WASTE MANAGEMENT OF HAWAII, INC.
92-460 Farrington Highway
Kapolei, Hawaii 96707
(808) 668-2985

**RE: Solid Waste Management Permit Application
For renewal with Modification for Expansion, No. LF-0065-07
Waimanalo Gulch Sanitary Landfill
Located at: 92-460 Farrington Highway, Kapolei, Hawaii 96707**

On behalf of the City & County of Honolulu (CCH), Waste Management of Hawaii, Inc. (WMH), the operator of the Waimanalo Gulch Sanitary Landfill (WGSL), is responding to the Department of Health's (DOH) December 2, 2009 letter concerning comments to our expansion and renewal permit application and engineering design. WMH appreciates receiving and welcomes the opportunity to address DOH's comments.

NOTE

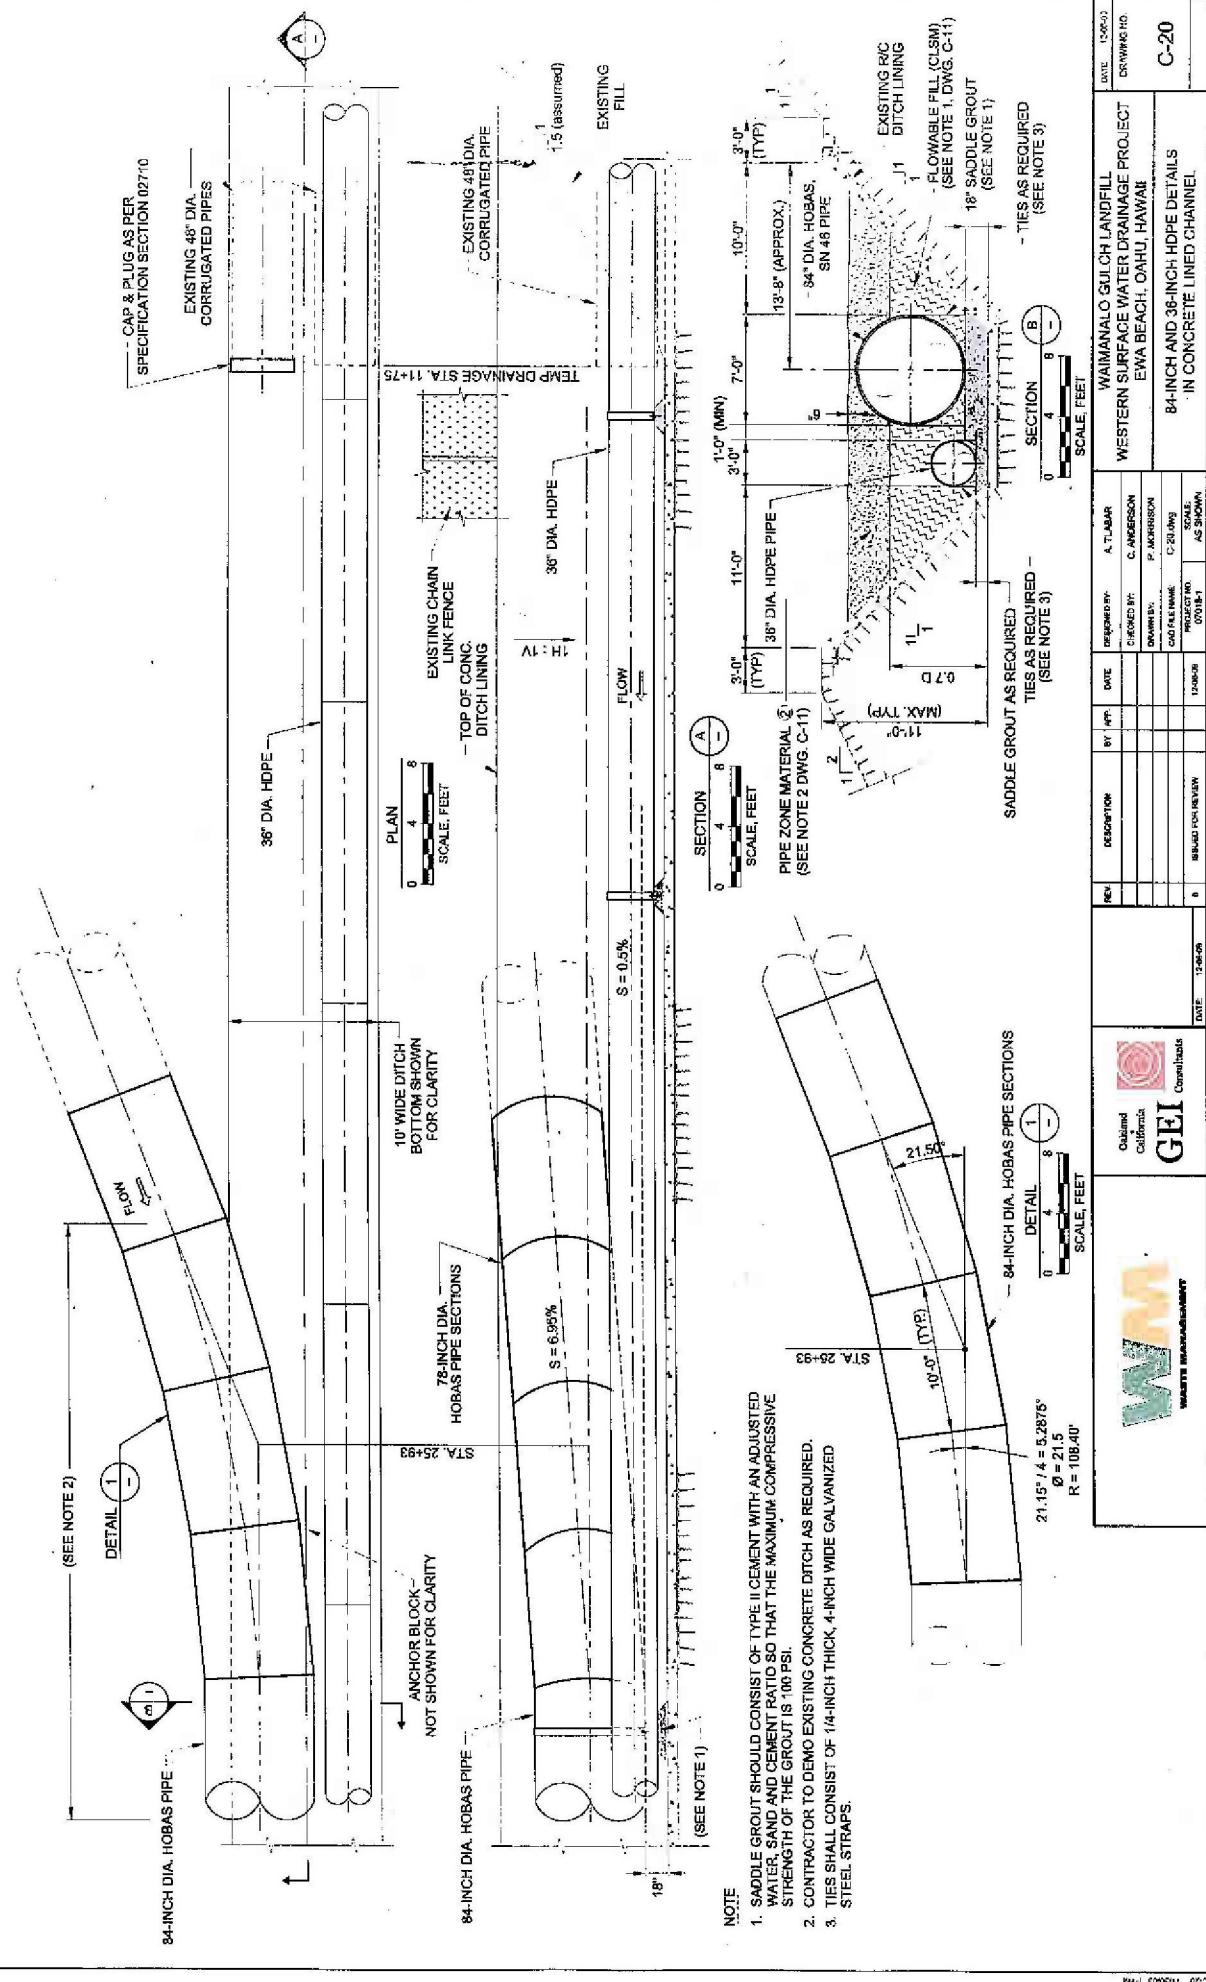
DOH Comment #3: *The subdrain trench containing the 30-inch and 36-inch diameter HDPE pipes, intending to drain surface water from the upper reaches of the gulch, do not have invert elevations and details on how the HDPE pipes are to be supported.*

DOH Comment #4: *Details of the connection of the new subdrain HDPE pipes to the existing 48-inch diameter corrugated metal pipes (CMPS) in the existing concrete channel are not provided. Portions (about 480 lineal feet) of the existing concrete channel and CMPS are to be removed, and the new subdrain HDPE pipes will connect to the existing CMPS downslope of the bottom of cell E6. Without invert elevations for the new subdrain trench and the existing CMPS, it is not known what elevation adjustments will be needed for the new HDPE pipes, which are running seven (7) feet below the cushion layer underlying the base liner, to meet the existing CMPS. It would appear that the HDPE pipes would need to rise up to meet the CMPS.*

WM Response #3: The pipe in a trench design cited by the HDOH was modified. Stormwater from the upper reaches of the landfill footprint and, temporarily, flow from the drainage located east of the old Nike site will now be conveyed in a single 36-inch diameter HDPE temporary diversion pipe that will discharge into the existing concrete channel downstream of the temporary stockpile (approximately 1,600 feet upstream of Farrington Highway). The 36-inch diameter HDPE temporary diversion pipe will be inserted into the east existing CMP, and the west CMP will be abandoned by capping at the upstream and downstream ends once the west side drainage channel has been completed. After the downstream end of the 36-inch HDPE pipe exits the east CMP, it will be placed next to the Western Surface Water Drainage Pipe in the existing channel and backfilled with controlled low strength material (CLSM). The downstream portion of the existing concrete channel will be preserved to convey discharge for the temporary diversion pipe and the interior landfill drainage to the existing sedimentation and stilling basin.

This modification is described in Appendix G, Western Bypass Channel of the *Revised Engineering Report for Landfill Expansion* submitted to the HDOH on 24 November 2009. We have attached drawings (C-16 through C-20) showing plan and profile details of the 36-inch HDPE temporary diversion pipe to supplement the description of the system provided in Appendix G.

WM Response #4: The temporary surface run-on drainage control will now consist of a single 36-inch HDPE temporary pipe as discussed in the Response to Comment No. 3 above and depicted in attached Drawings C-16 through C-20. The temporary diversion pipe will be inserted into the existing, eastern 48-inch CMP located below the West Berm area. As shown on attached Drawings C-17 and C-18, the HDPE pipe will extend through the remaining length of the 48-inch CMP and then exit the CMP in the existing channel beneath the proposed stockpile area. These drawings also show invert elevations for the 36-inch HDPE diversion pipe in the Cell E6 area and West Berm areas. The HDPE diversion pipe invert elevations in the West Berm area are based on the approximate location and grade of the 48-inch CMP pipe and alignment of the existing channel (i.e., the invert of the 48-inch CMP was placed in the existing channel). Based on the alignment shown on Drawing C-17, we do not anticipate the HDPE pipes will need to rise up to meet the CMP invert elevation.
